HYDRAULIC LABORATORY REPORT NO. 43

# HYDRAULIC CHECK OF THE PROPOSED CRANE PRAIRIE DAM OUTLET WORKS STILLING BASIN

MEMORANDUM TO ENGINEER J. E. WARNOCK
(J. H. Douma, Junior Engr.)

Subject: Hydraulic check of the proposed Crane Prairie Dam Outlet Works Stilling Basin.

FIGURE 1

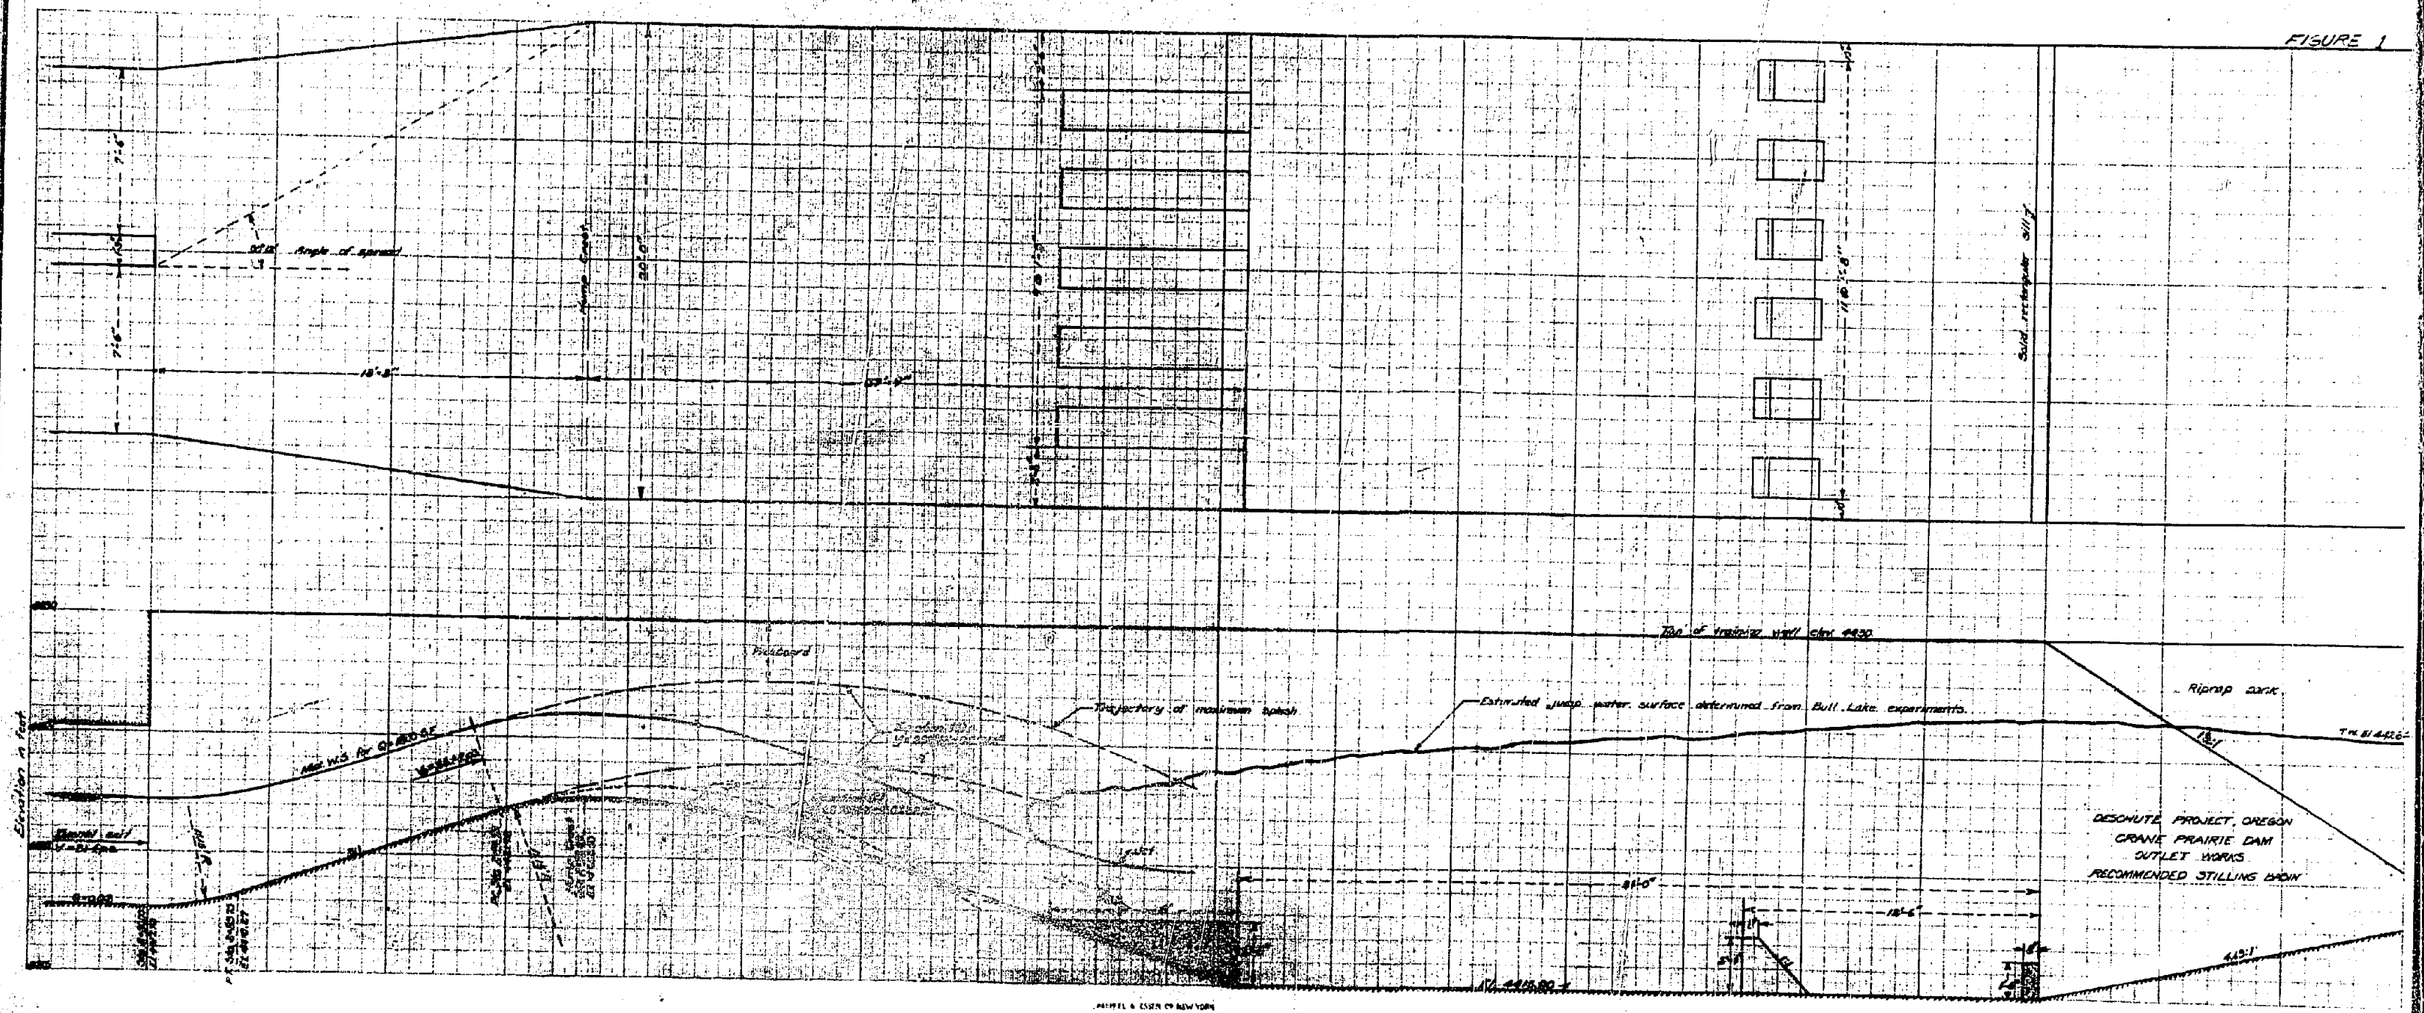
In figure 1, trajectories for equations (1) and (3) are plotted with the P.C. of the upstream hump slope as the beginning of the trajectory and an initial velocity of 26.1 feet per second parallel to the 3:1 upstream slope. The chute floor should follow the lower equation (3) trajectory if a smooth jet is required over the hump. The trajectory for equation (1) based on the mean cross-sectional velocity, lies above the proposed trajectory, which, according to previous design methods suggests a region of negative pressure, and a tendency for the jet to spring clear of the bottom.

When the equation (3) trajectory is plotted from the jet water surface, this curve will approximately represent the path of maximum splash. With the proposed design, there will probably be considerable disruption of the jet on its surface, similar to Kittitas; but this will have no harmful effect since there is excess freeboard and the jet splash will enter the pool at the beginning of the jump. The proposed downstream hump profile is satisfactory except that the

equation of the parabola is changed slightly to $y = -0.01587\ x^2$ so that the 3:1 slope will end at Station 3+24.00.

A conservative value of $V_1$ is 33.7 feet per second and $d_1$ is 2.67 feet. From the diagram, $d_2$ is 12.6 feet and $d'_2$ is 10.7 feet. With the maximum tailwater at elevation 4426, the proposed floor can be raised two feet to elevation 4415.00. The basin length is given as 37.8 feet. With the 17 feet long end transition a 34-foot length is sufficient. The diagram gives the following block and sill dimensions: $h_1 = 2.67' = 2'-8"$; $h_2 = 2.3' = 2'-4"$; $h_3 = 1.6' = 1'-6"$; $a = 12.6' = 12'-6"$. For economical and structural reasons, the small end sill should be rectangular in cross-section. The recommended design is shown in figure 1. The stilling basin dimensions compare favorably with those of the adopted Bull Lake design.
